TYP. BM. TO PILE CONNECTION
4" MAX. TOTAL MISALIGNMENT

BEAM TO PILE CONNECTION WHERE
MISALIGNMENT EXCEEDS 4" MAX TOTAL.

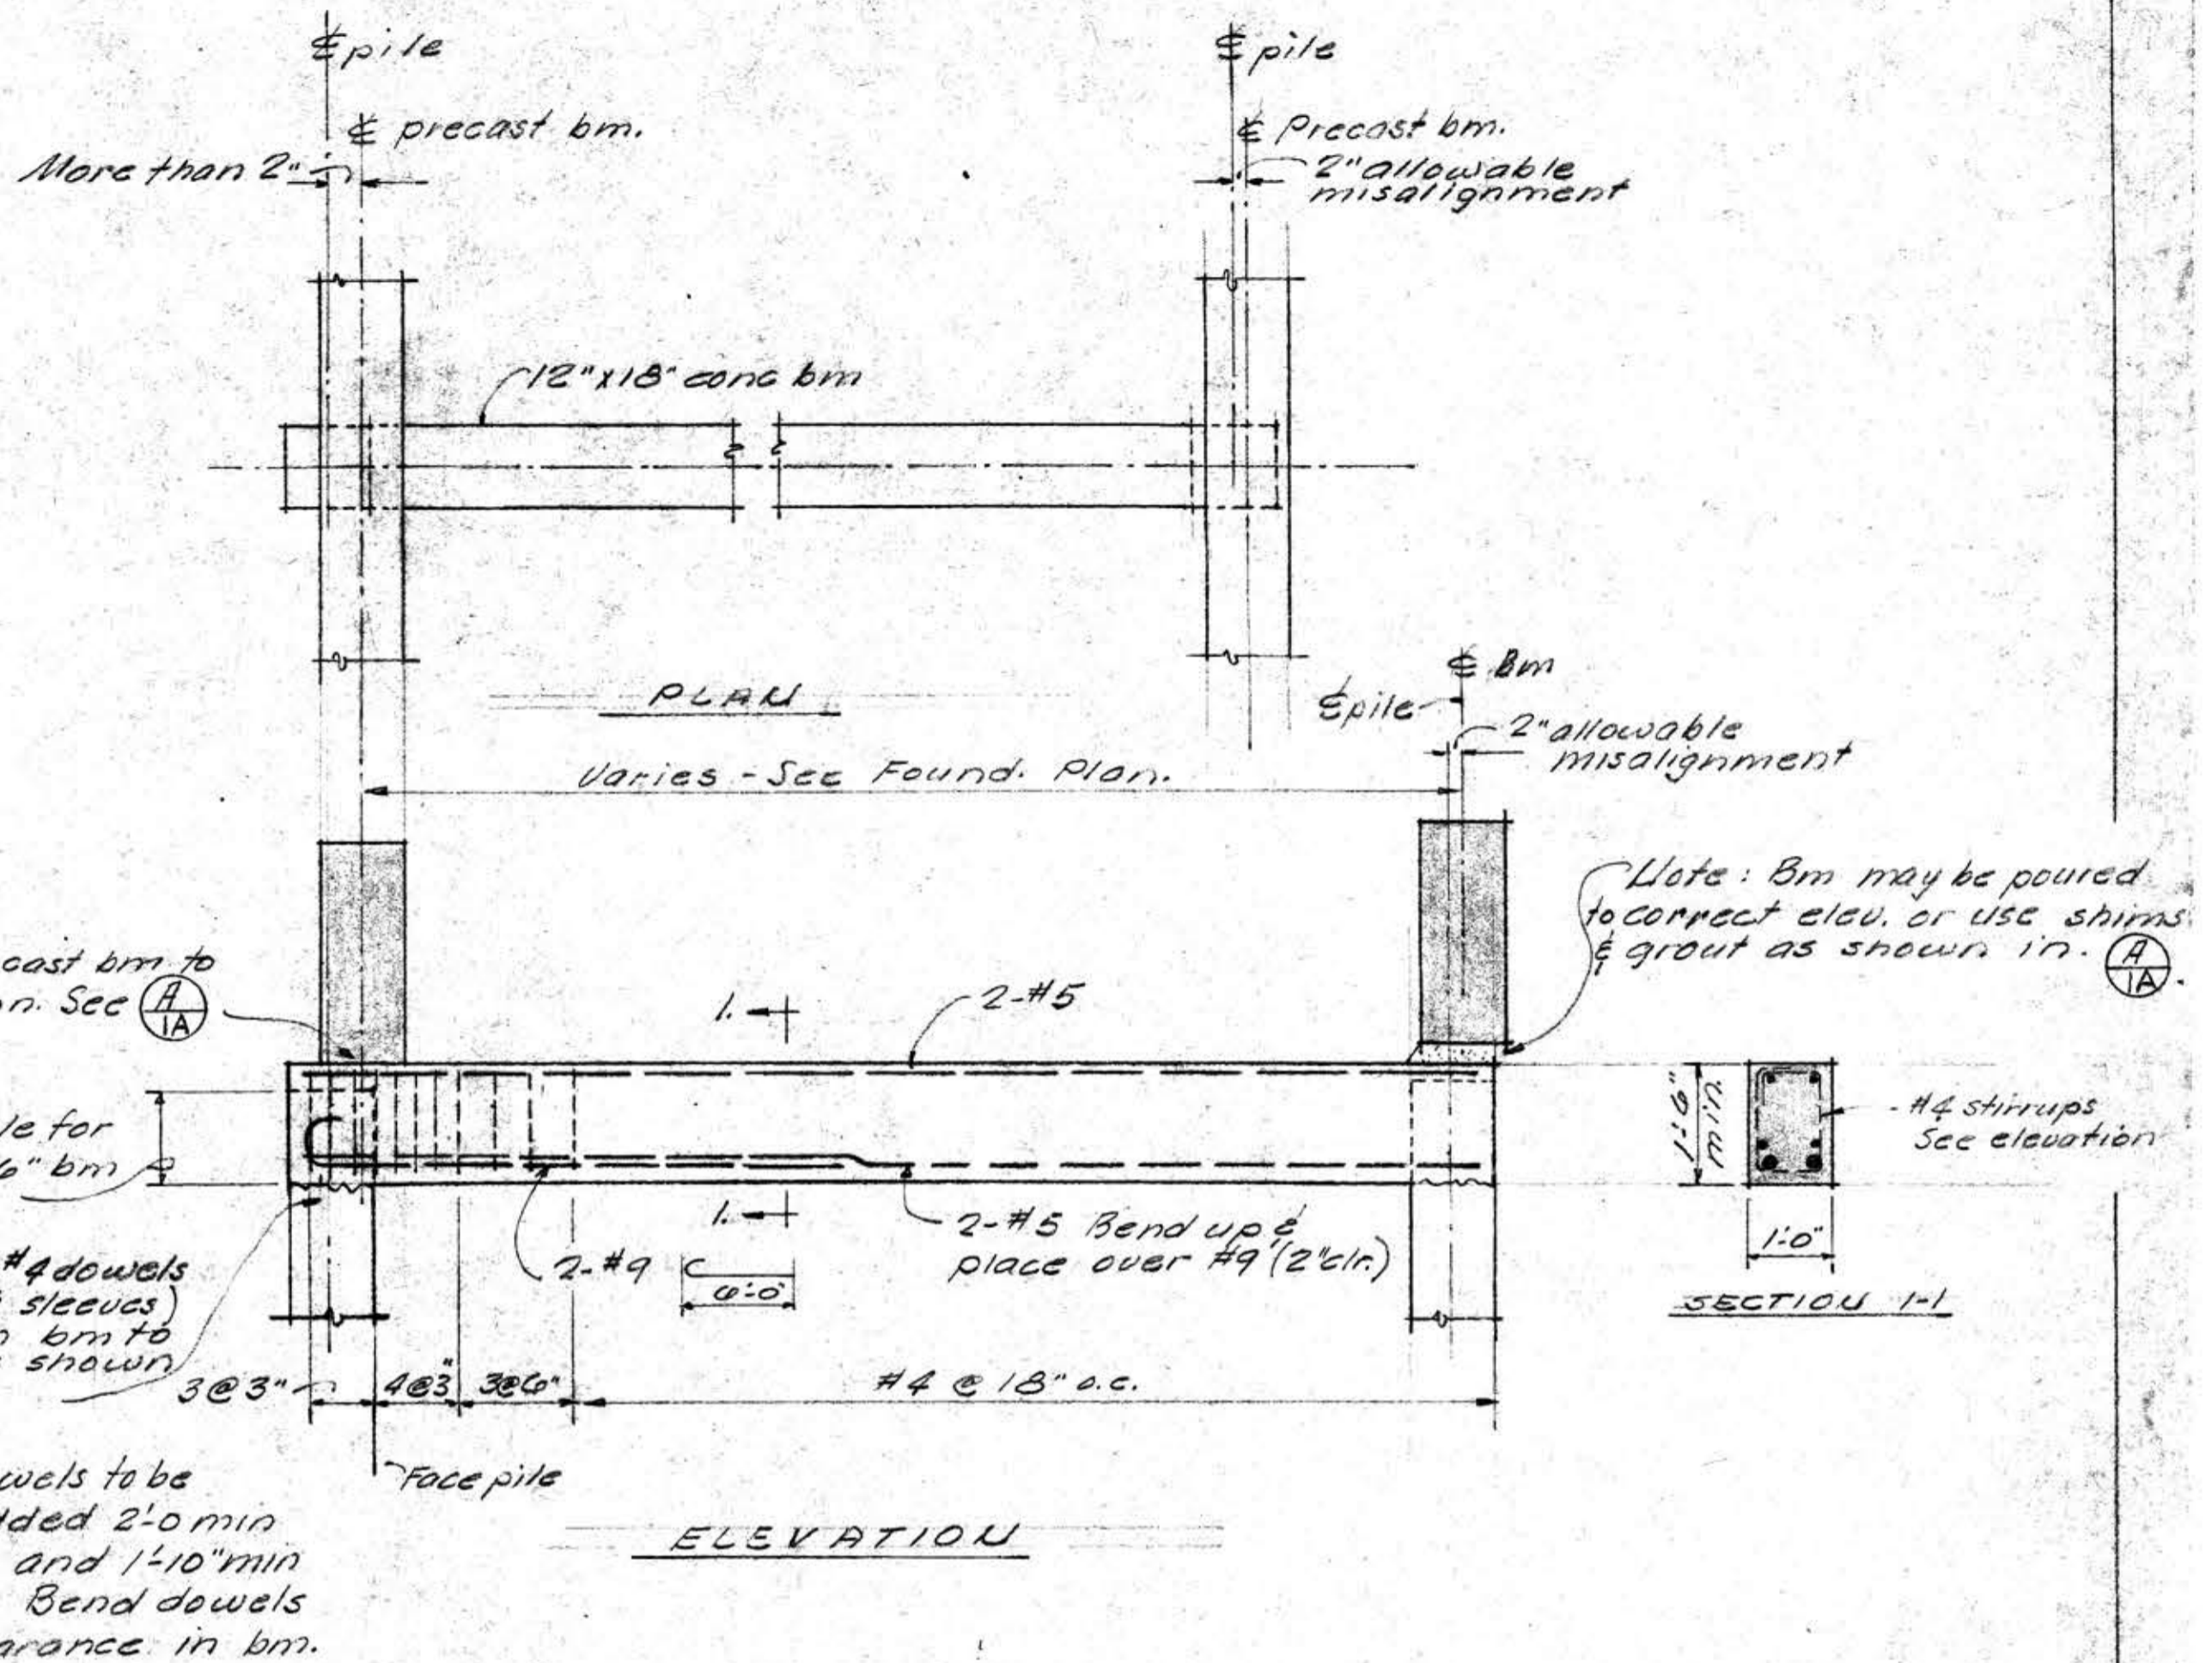
NOTE: Pile #27 13" out of alignment Refer Sh 3 Lot 16 Block 3
 Note 5-2x4 studs called for on plan Sh 3.
 Dtl (H) calls for 2-2x10 @ typical 1st floor level. Add 3-2x10
 for total of 5-2x10 @ typical 1st floor level for full
 bearing of 5-2x4 studs.
